DRAINAGE MANAGEMENT PLAN

Werner Gilchrest House
202-206 Cornell SE
Albuquerque, N.M.

GRADING/DRAINAGE PLAN

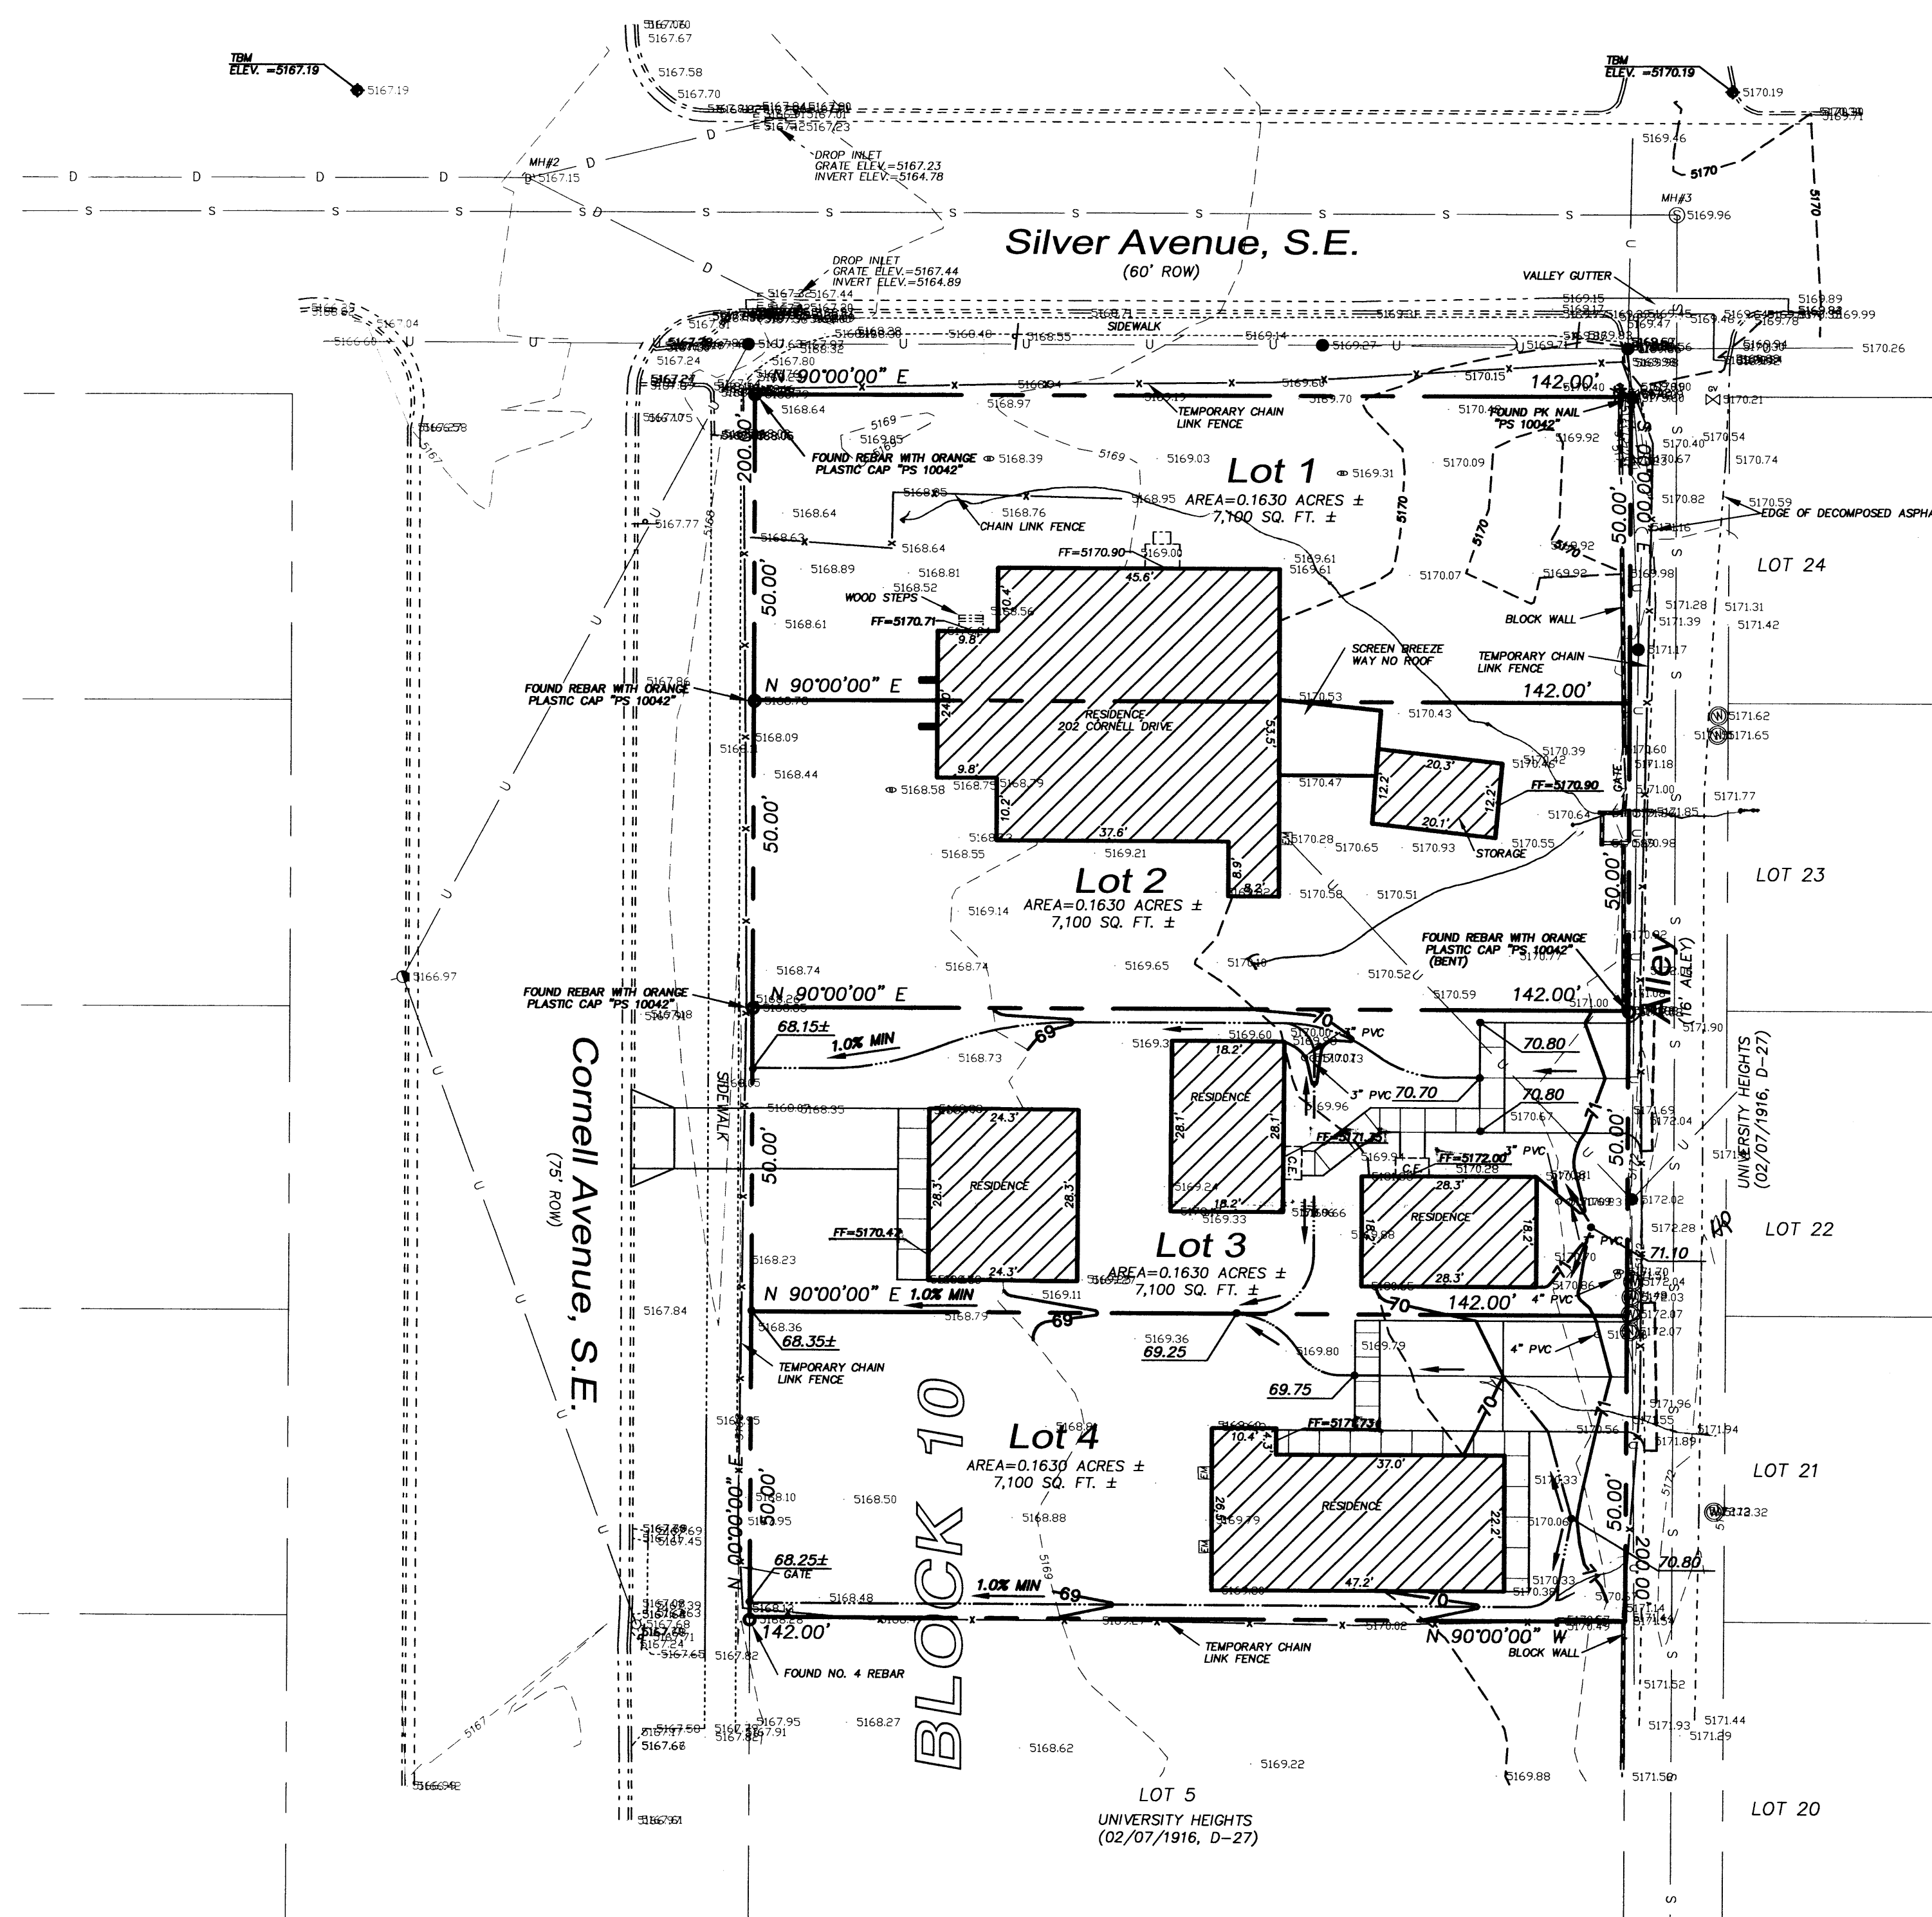
Offsite flow?
